Mt. Olive Creek, Solar, LLC
Response to Siting Board's Second Request for Information
Case No. 2020-00226

Scenario 1: 2 pile-drivers (125dBA) and 6 trucks/excavators (85dbA) deployed at the same time:

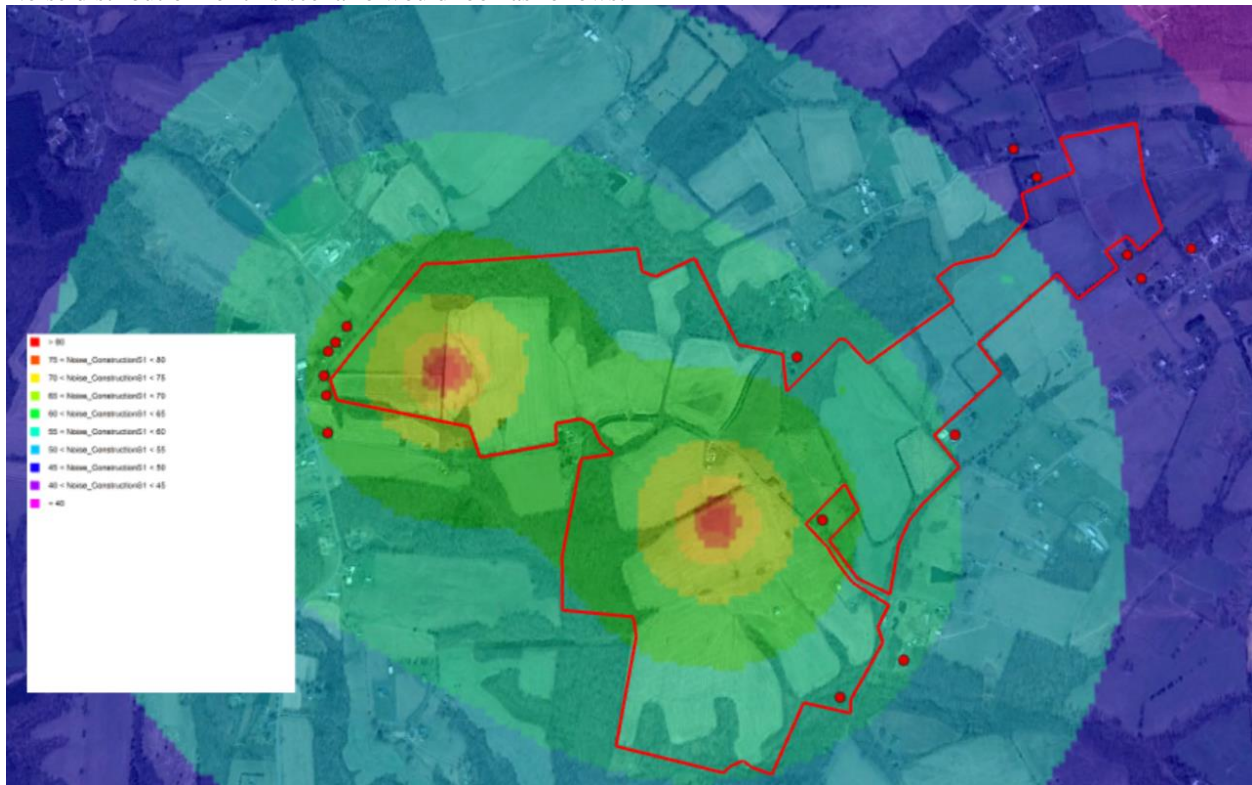
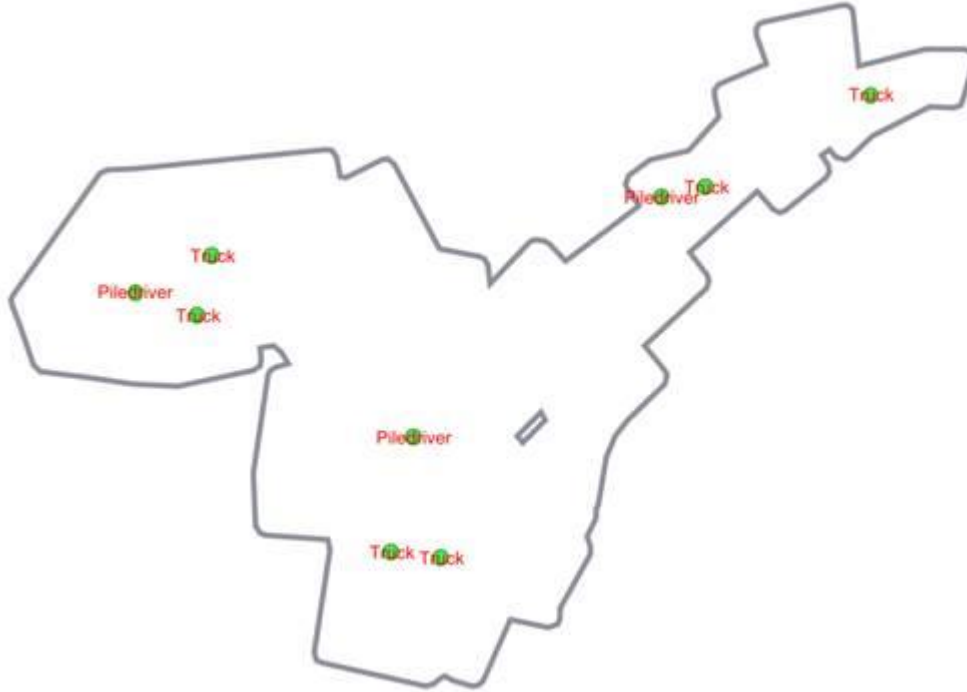
Request No. 10: Provide a table showing (1) distances from the Project boundary in 100-foot intervals; (2) peak construction noise levels at that distance; including ALL construction activities and noise from vehicles; (3) the duration of that peak noise level at that distance (in days or weeks); and confirm that is assuming that all noise receptors surrounding the site at a distance of 200 feet would experience the same peak noise level for the same amount of time over the course of the construction period.

For illustrative purposes, the following two scenarios simulate noise levels in certain distances from the project with certain equipment deployed at the same time:

Noise distribution for this scenario would look as follows:

Distance from Project Boundary (ft)	Estimated Maximum Noise Level (dBA) with 2 x Piledrivers + 6 Trucks
100	64
200	63
300	62
5000	61
1000	59
1500	57

Mt Olive Creek Solar Nearest Residences Map

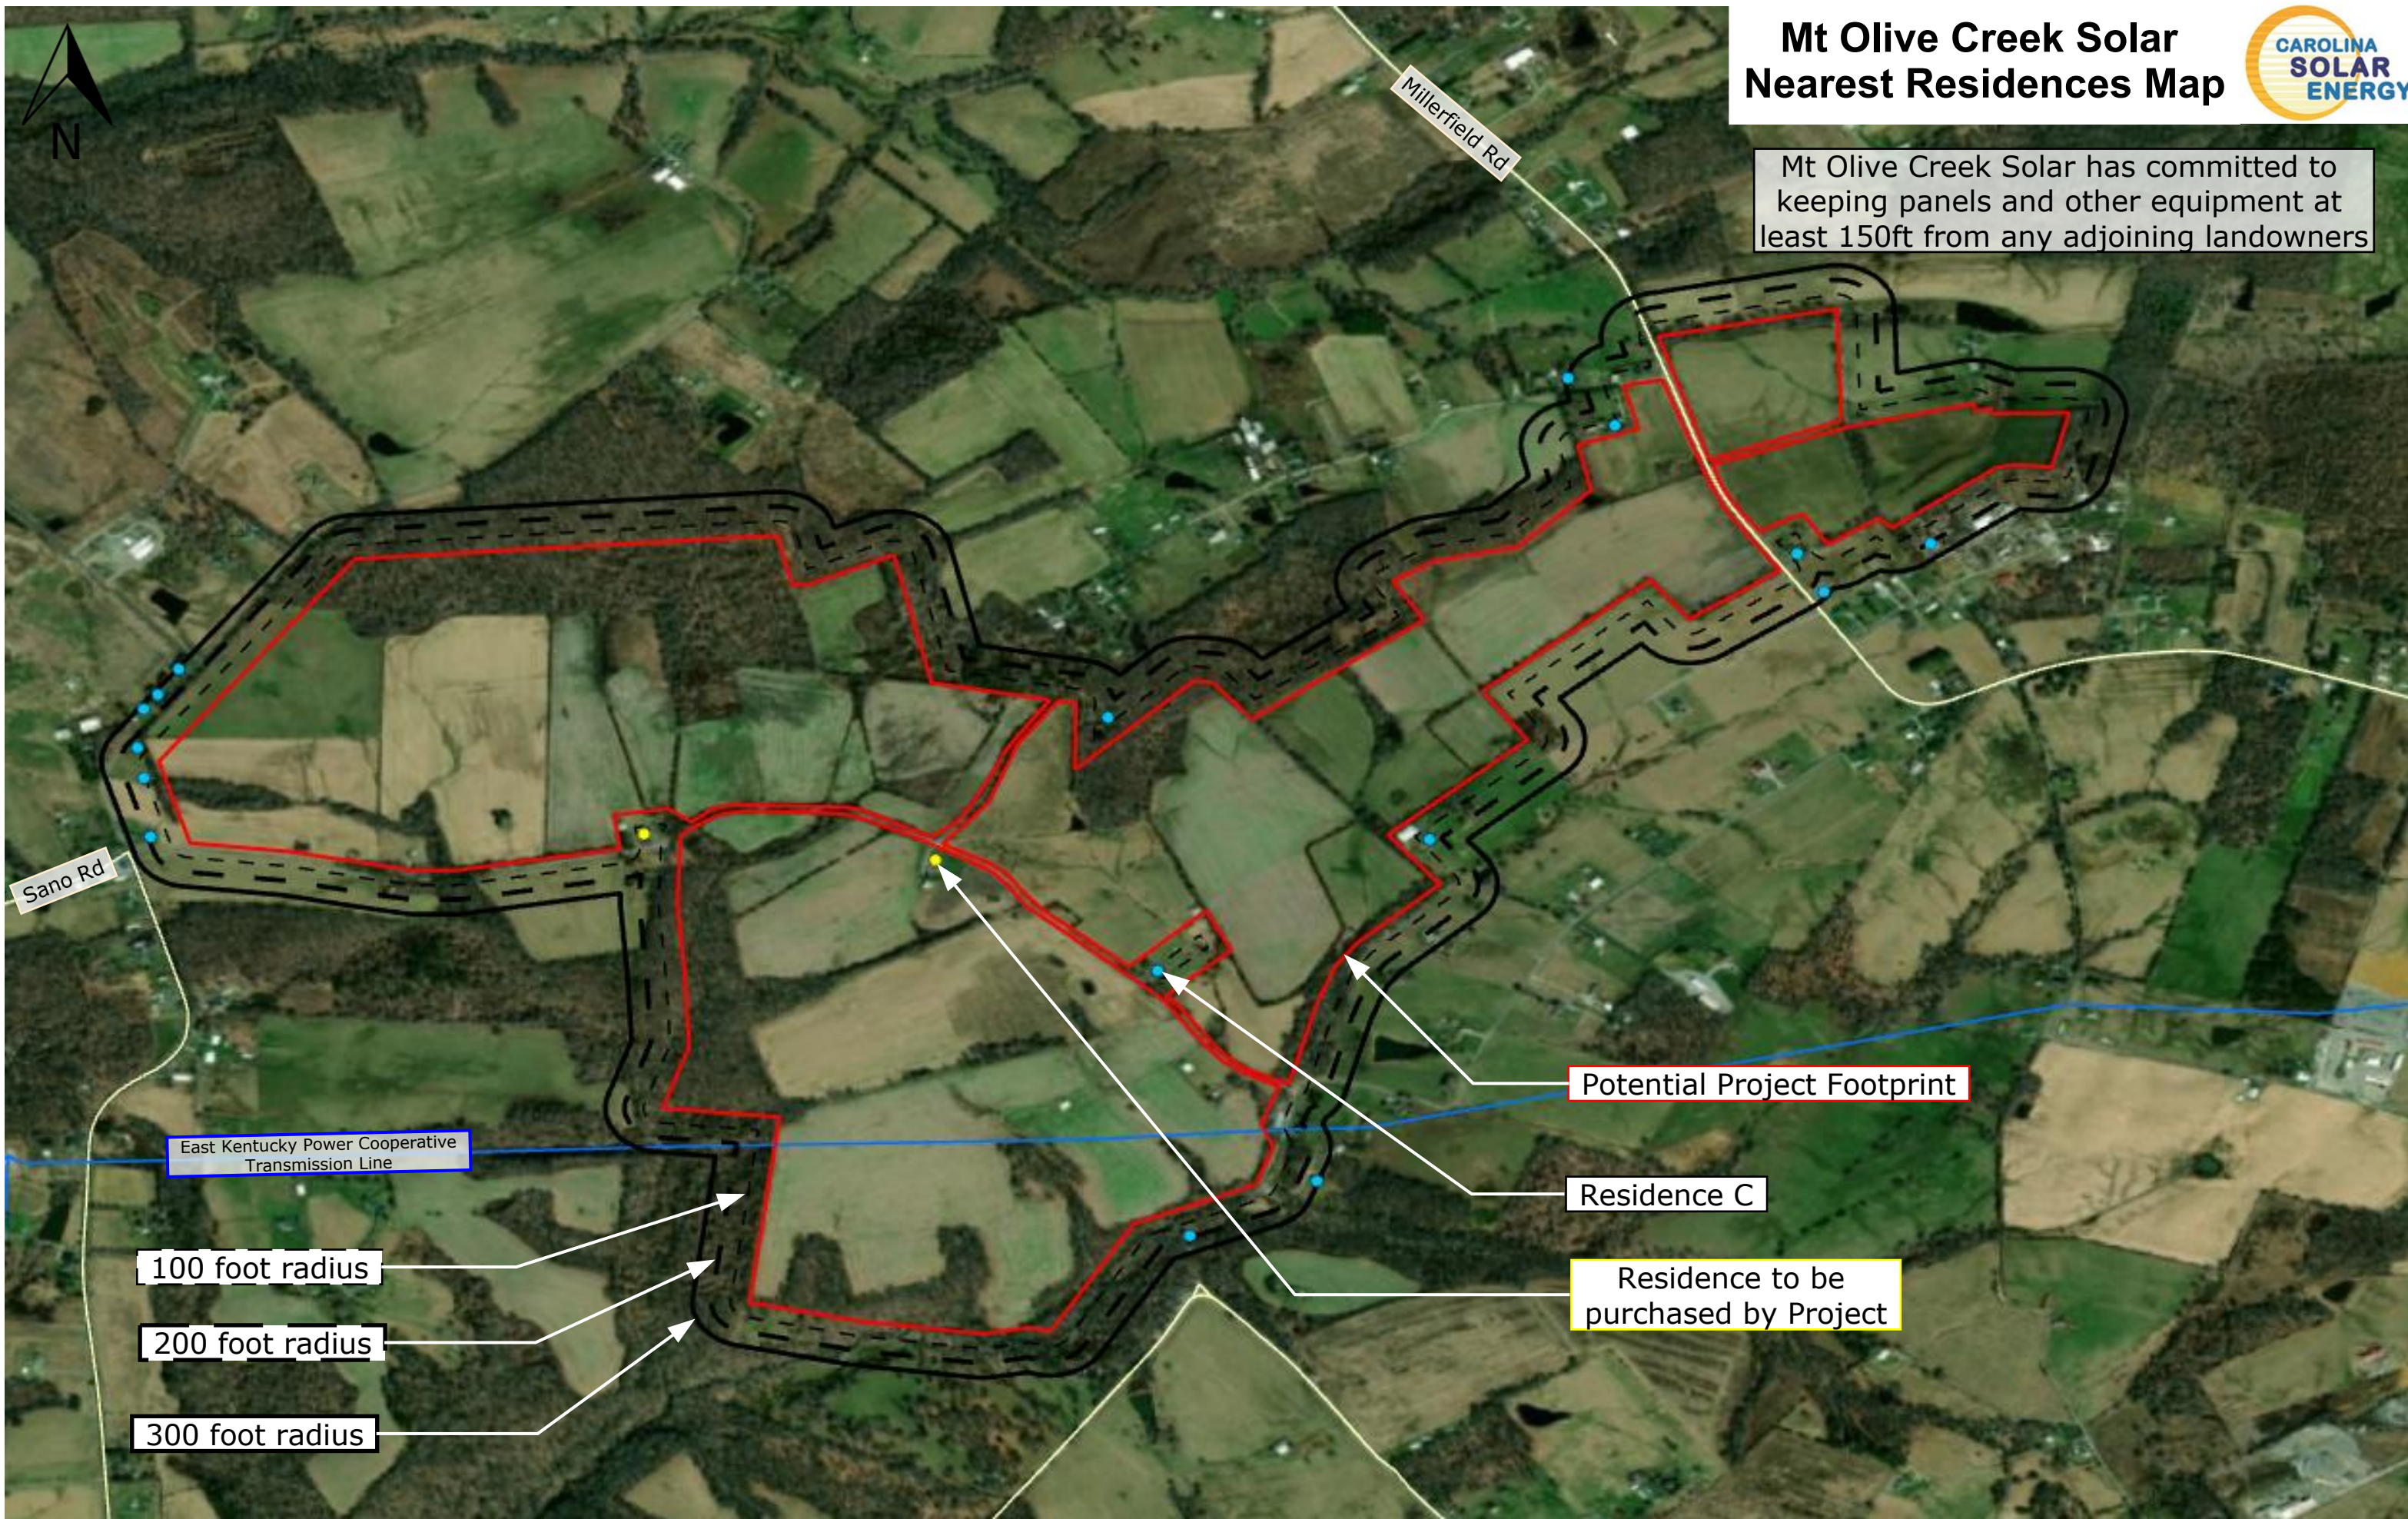
- a. Explain whether that transaction the purchase of the property identified as Residence C on the Map of Nearest Neighbors (Attachment C of the SAR).
- b. If yes, explain whether the vegetative buffer located along Sano Road in the vicinity of that residence still be developed.
- c. If not, provide a revised map of the final locations of the proposed vegetative buffers.

- a. No, residence C is not a property being purchased by the Project. See the attached clarifying map for the property that will be purchased that would have been surrounded by the project.
- b. The vegetative buffer will be installed in accordance with the proposed site plan.
- c. The vegetative buffer will be installed in accordance with the proposed site plan.
